**City of Bellevue  
Development Services Department  
Land Use Staff Report**

**Proposal Name:** COBT – PW-R 185 SE Newport Way

**File Number:** 18-111915-LO

**Decisions Included** Critical Areas Land Use Permit - (Process II. 20.30P)

SE NEWPORT WAY  
150TH AVENUE SE TO SOMERSET BLVD  
ROADWAY  
PLAN AND PROFILE

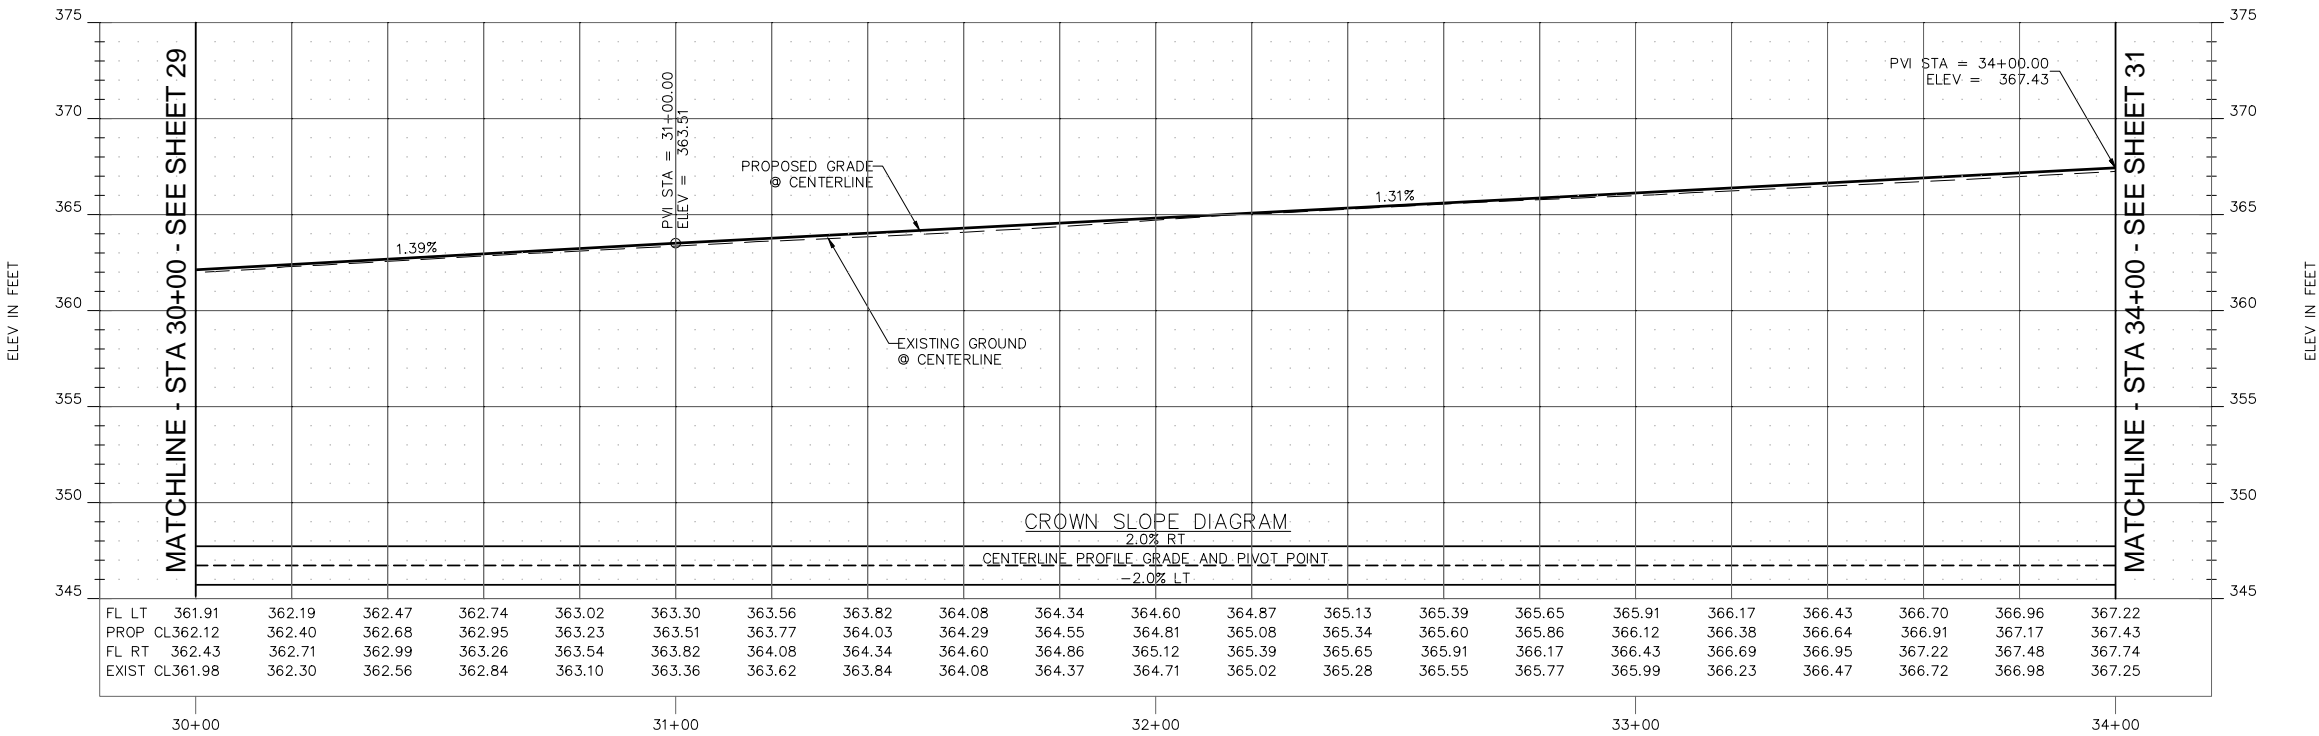
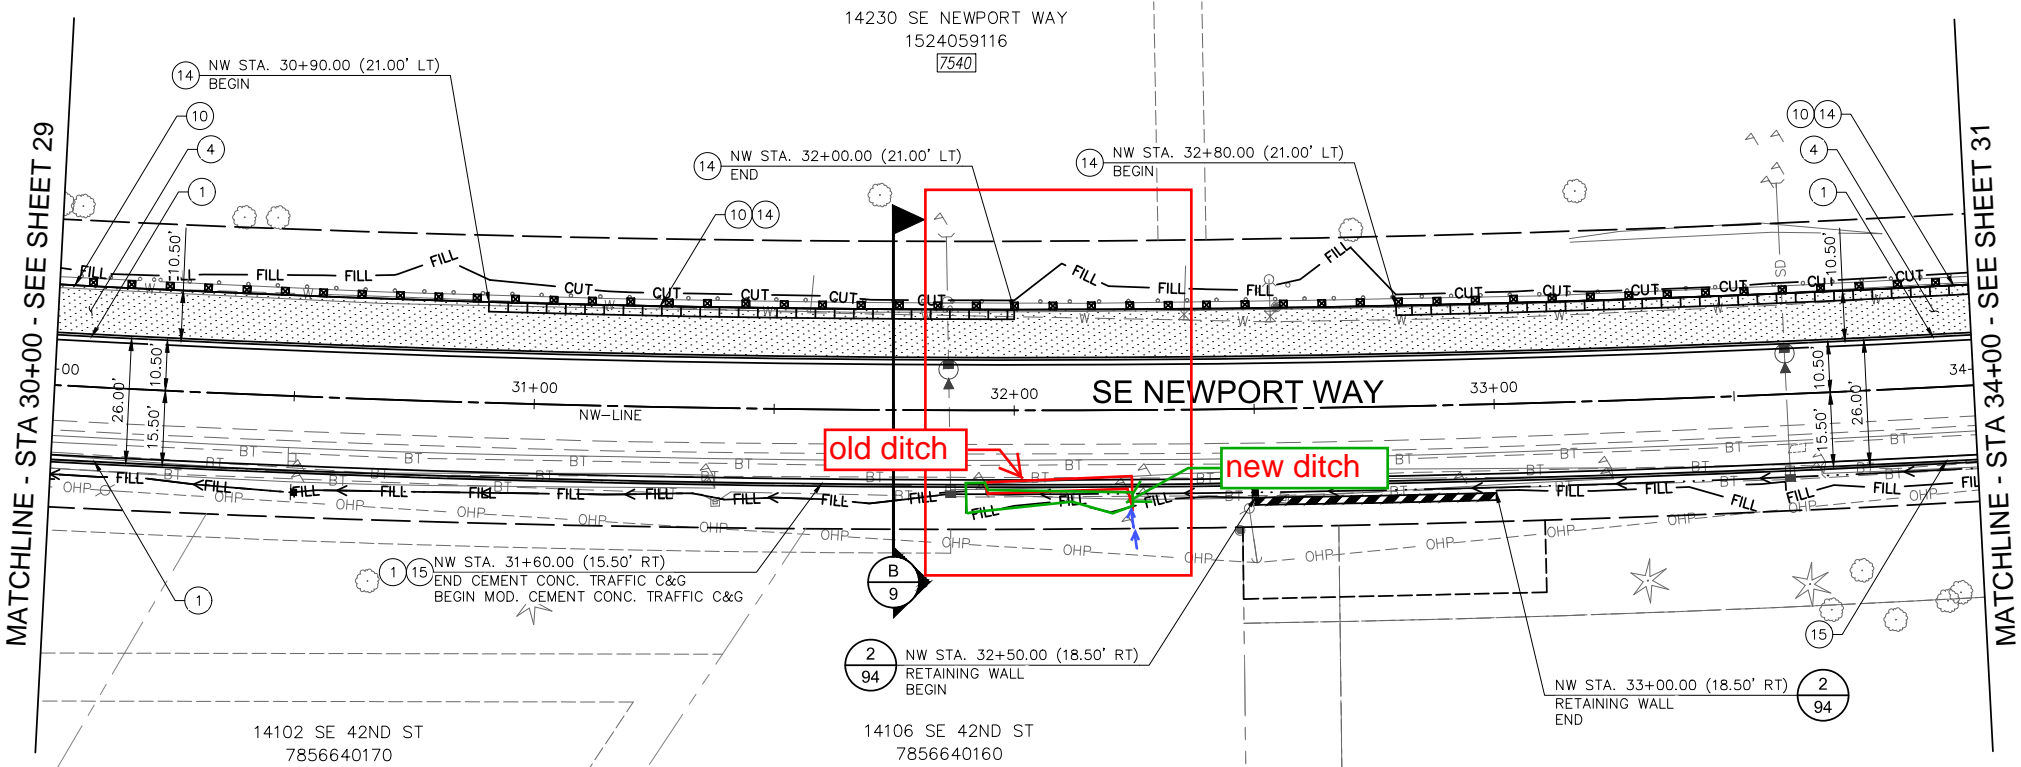
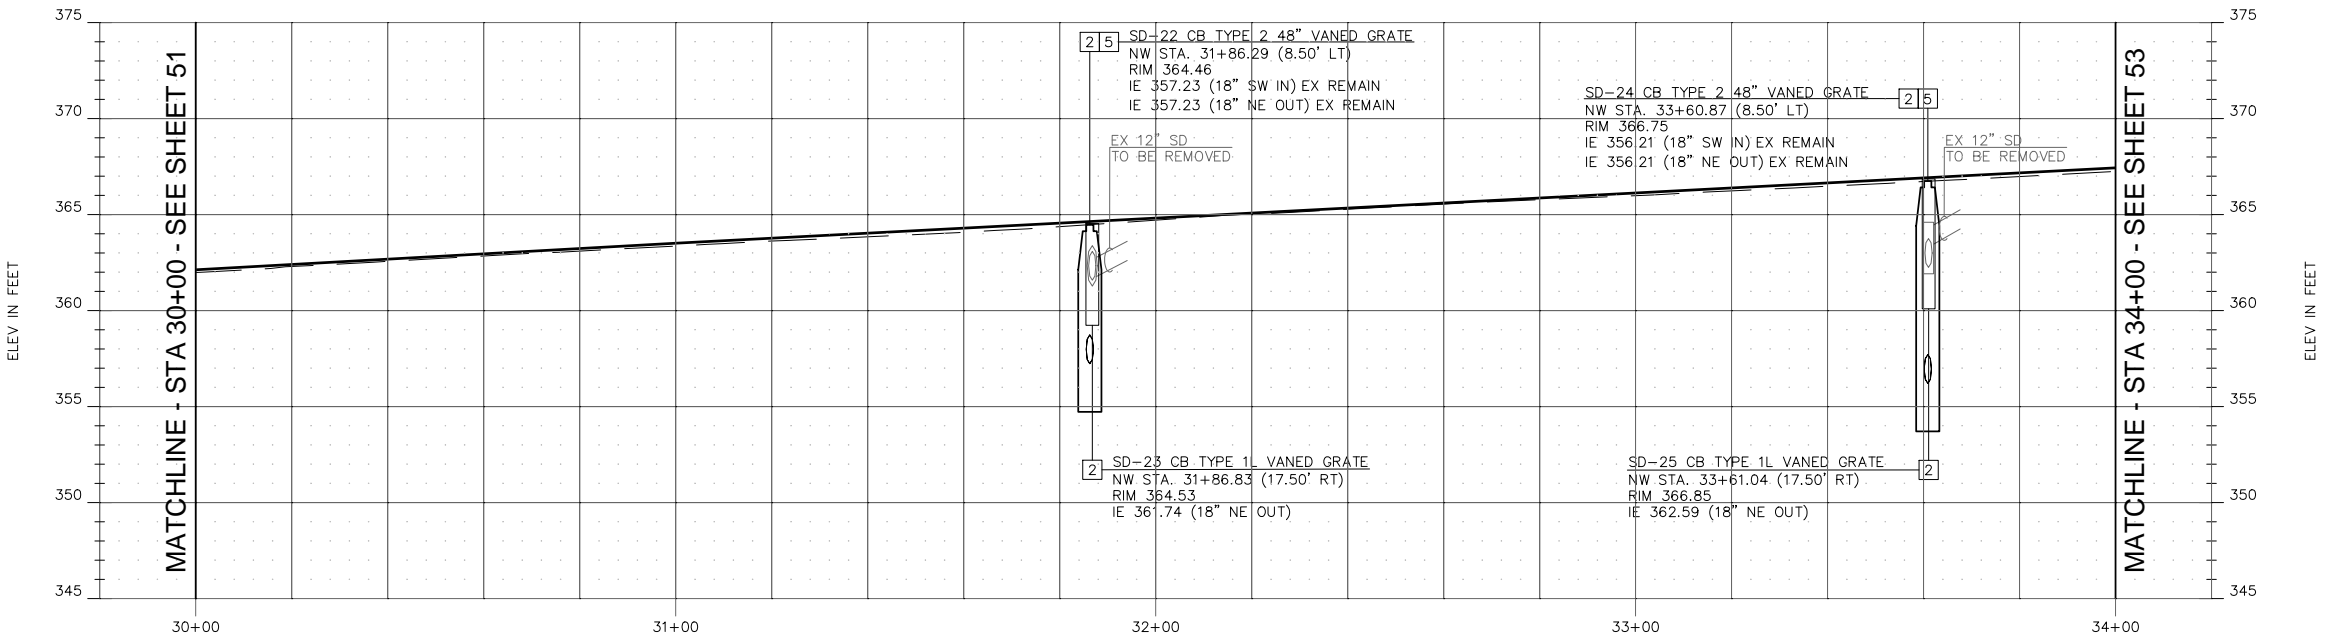
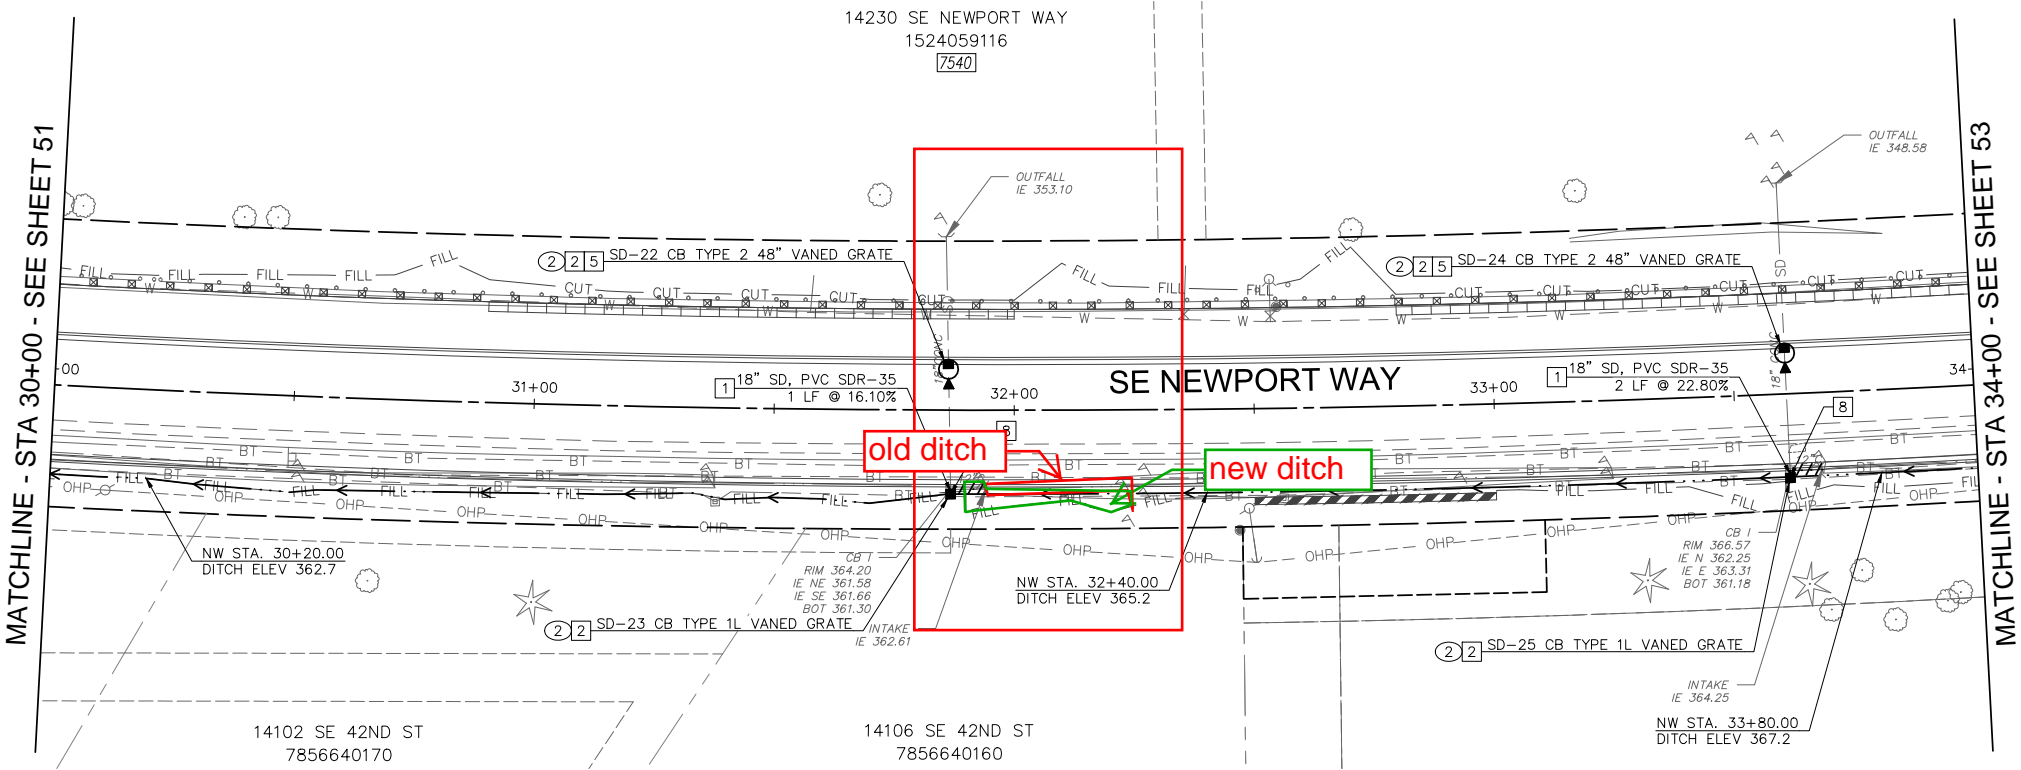
Karen has asked for drawings showing where the stream where be relocated and the Corps needs to know this as well. We have several drawing showing existing conditions and impacts but we need to know where you propose to relocate Stream 1.

We asked for the drawing details showing the stream relocation proposed for Stream 1. We checked the plan set and were unable to find this project detail. Please have the applicant provide the plan sheet showing the proposed relocated section of Stream 1 in both plan and profile views.

The only portion of Stream 1 that we are relocating is where it flows in the roadside ditch, which will be moved immediately south of the existing ditch. These are the only plans that we have, but you can see where the old ditch is because I delineated it (see flags), and you can see where the new ditch will be based on the fill locations. I've added polygons to the sheets to clarify. Hopefully, this will be enough info...?

Here are the plan sheets that pertain to Stream 1. Red boxes were added to the sheets to make it easier to see where Stream 1 is located.
